Response to CEC Staff Data Adequacy Comments

Technical Area: Project Overview

PALMDALE HYBRID POWER PROJECT

FIGURE 2-10

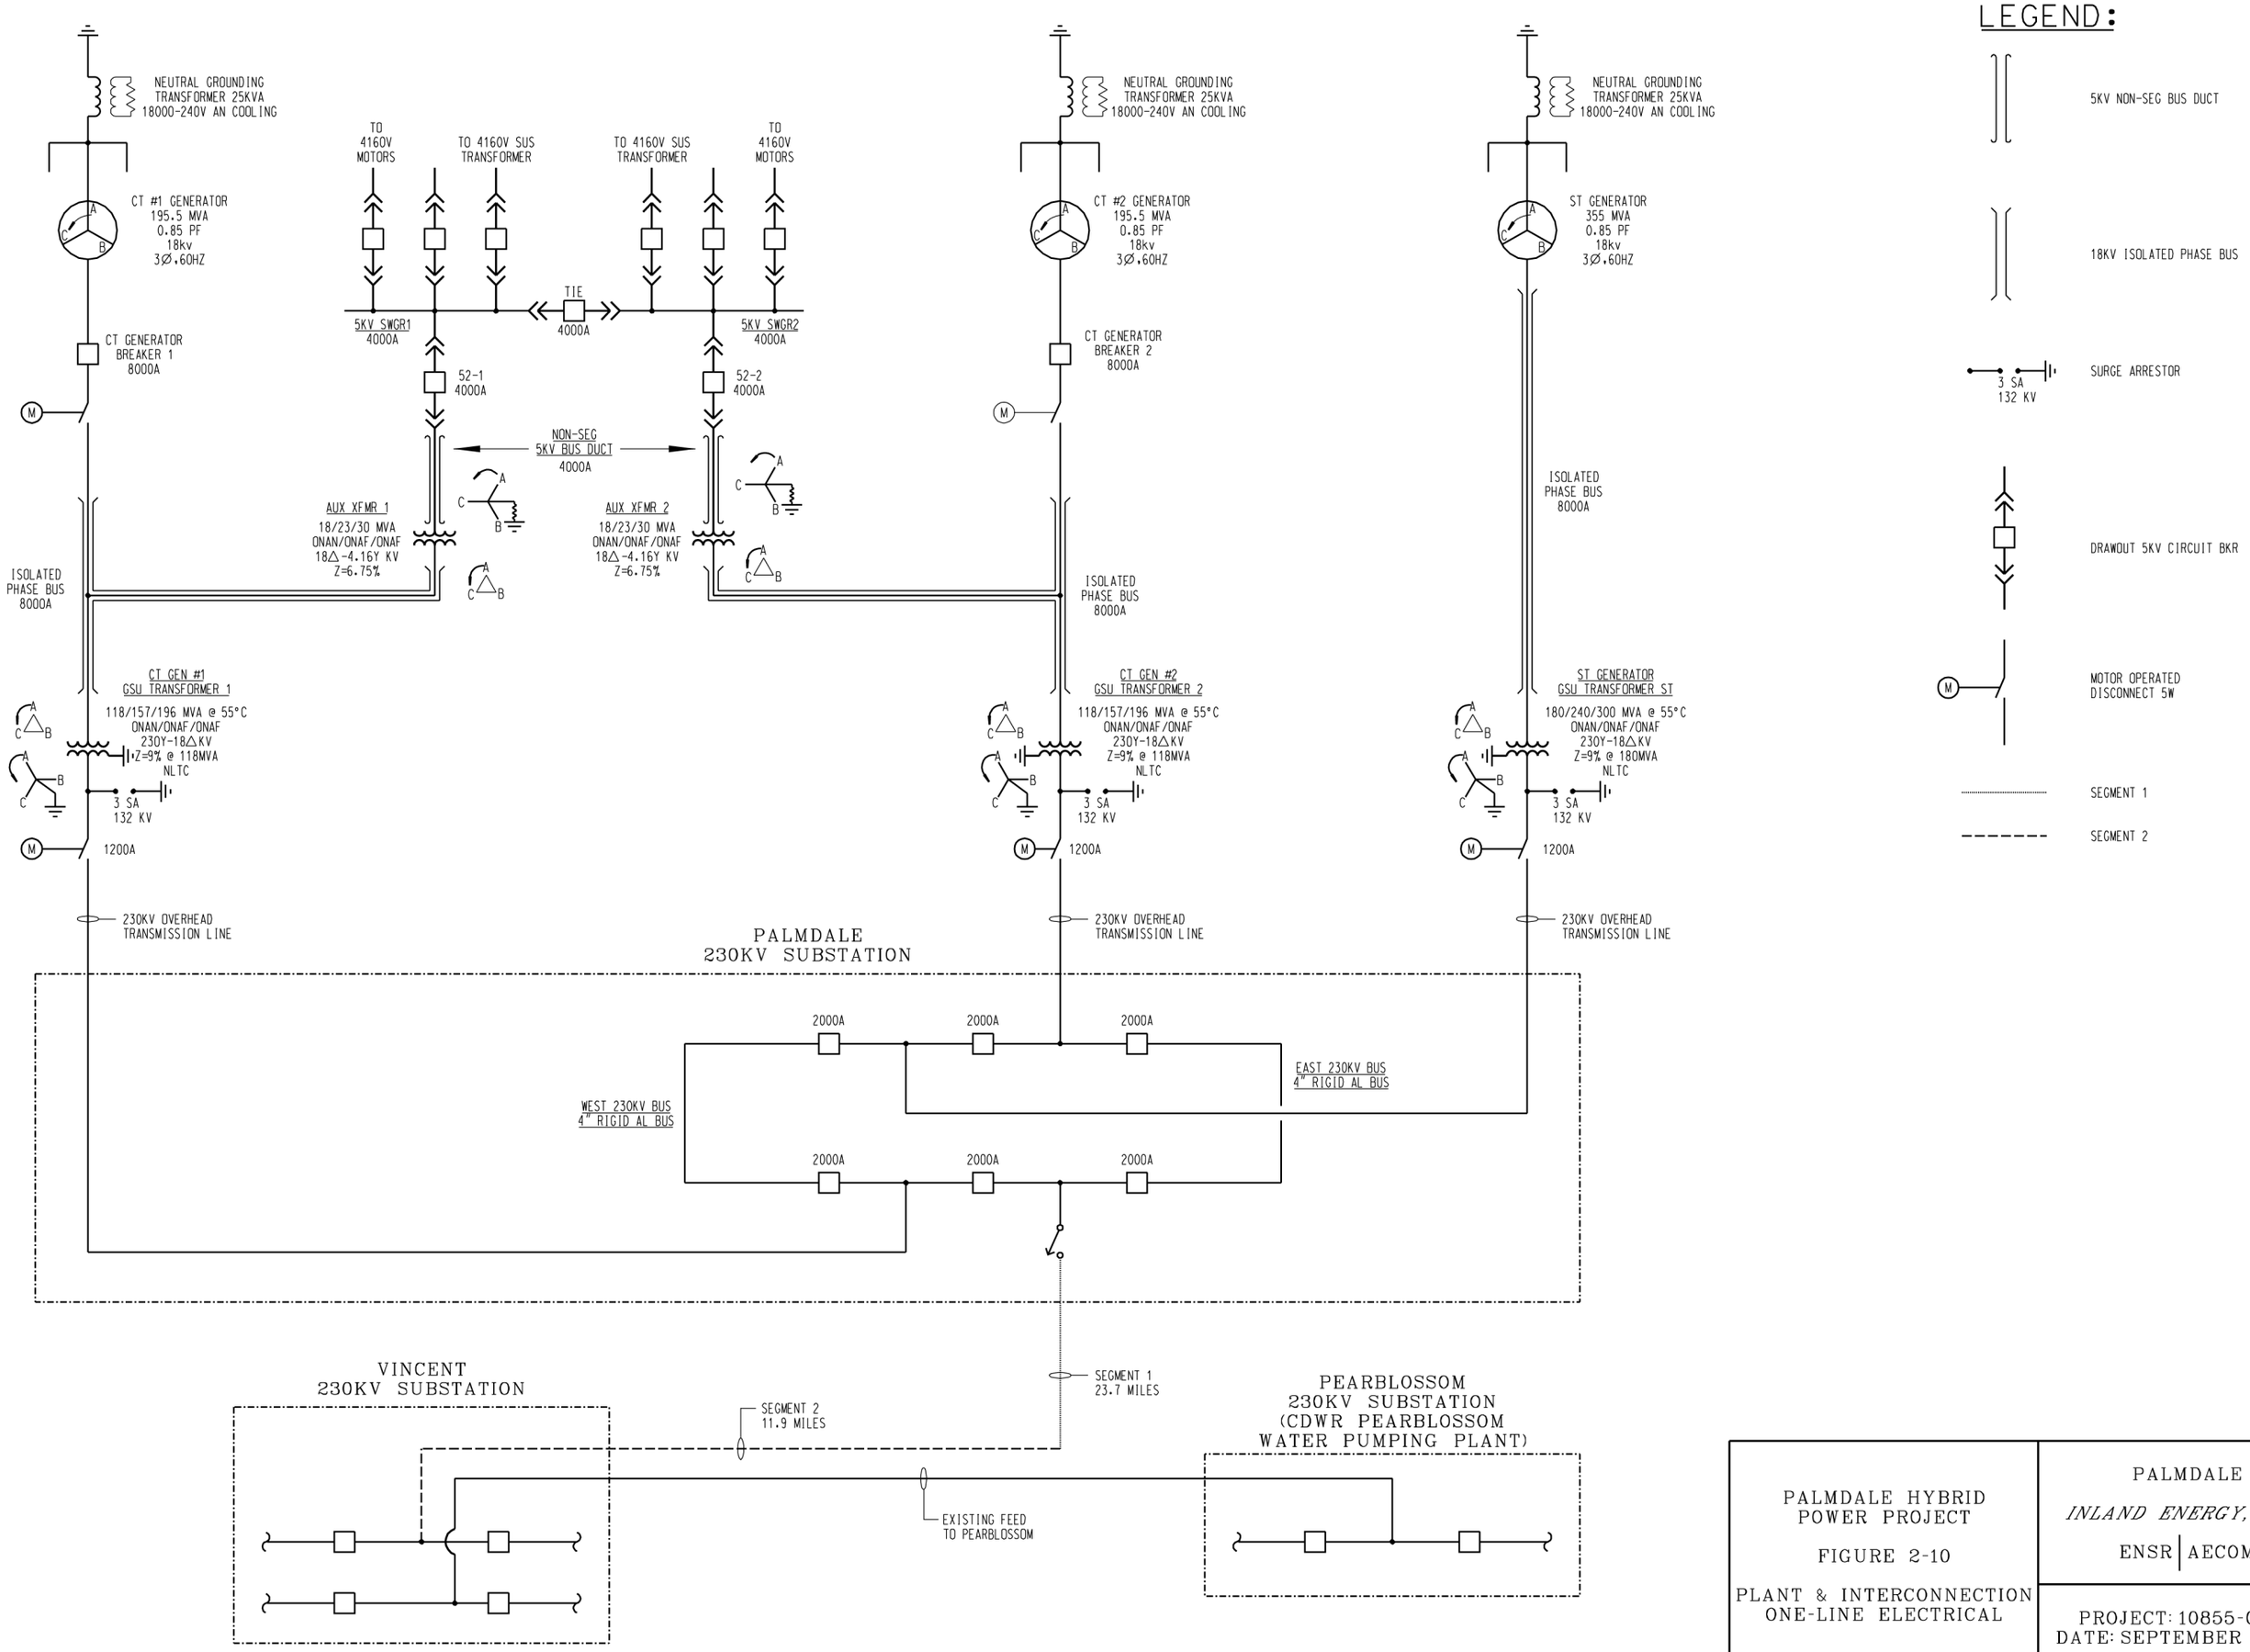
1. Please resubmit Figure 2-10. Show all equipment ratings including generators, transformers, circuit breakers, disconnect switches, and etc. which required for the project.

Please see attached Figures 2-10 and 2-10C.

PALMDALE HYBRID POWER PROJECT FIGURE 2-10A PALMDALE SITE SUBSTATION TAKE-OFF STRUCTURE	PALMDALE *INLAND ENERGY, INC.* ENSR | AECOM PROJECT: 10855-002 DATE: SEPTEMBER 2008

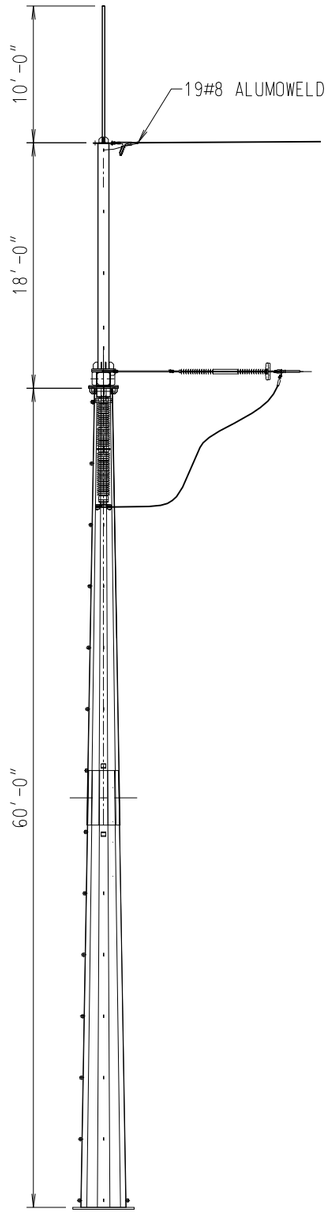
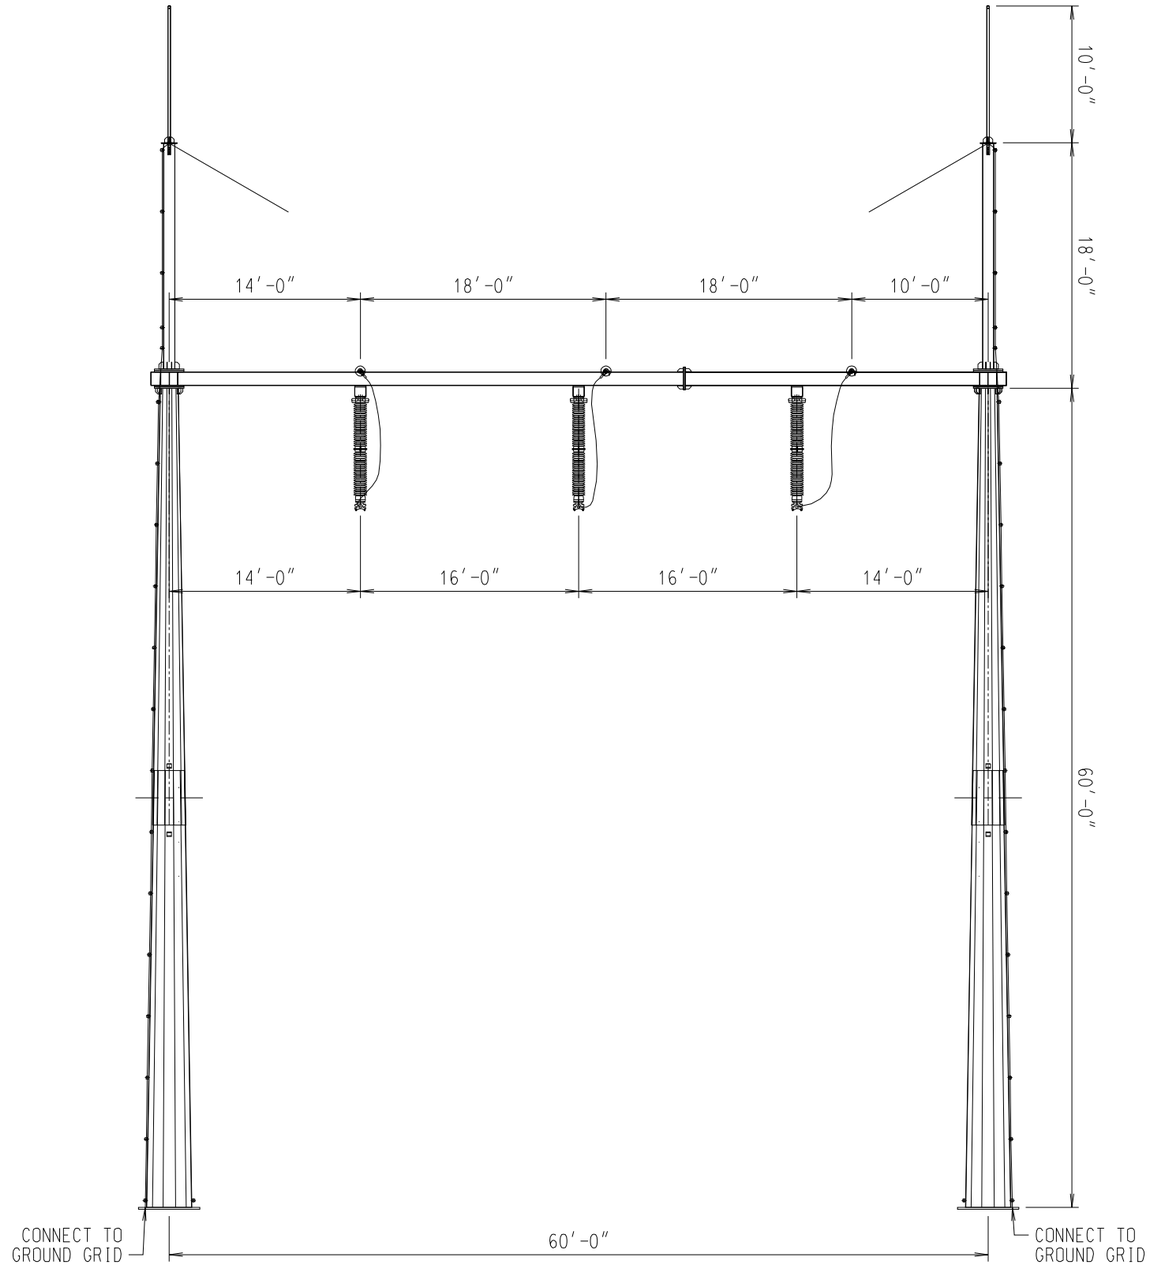
2. Please provide detail drawings for the take off structures which are required in interconnecting the 230 kV transmission lines from the proposed power plant to the existing Vincent Substation.

Please see attached Figure 2-10A.

FIGURE 2-10B

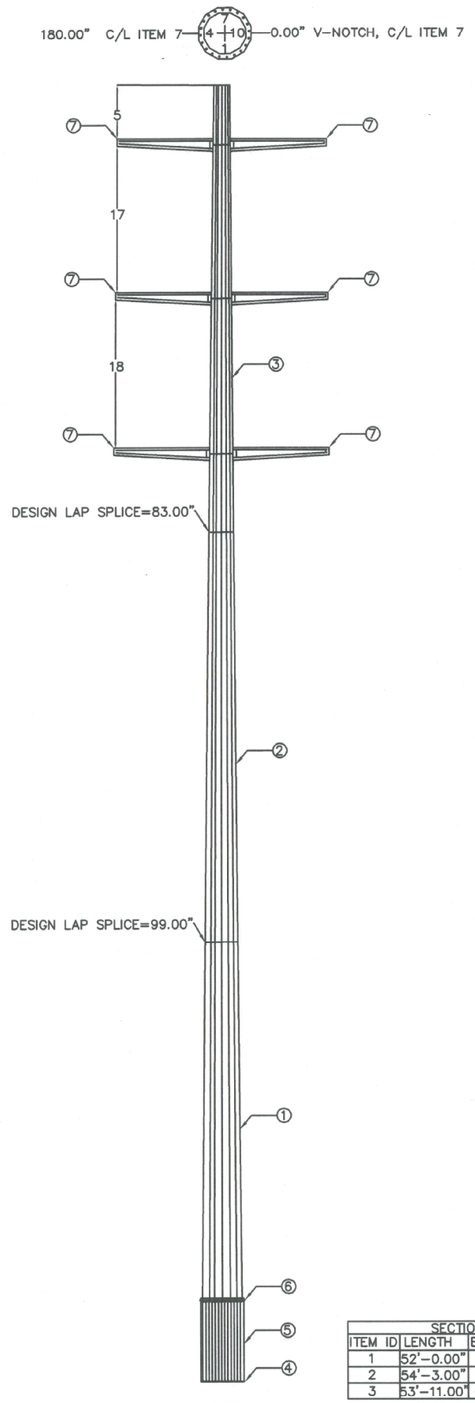
5. Please provide transmission pole/tower configurations which would be used to support the generation tie-line from the proposed project to the Vincent Substation.

Please see attached Figure 2-10B.
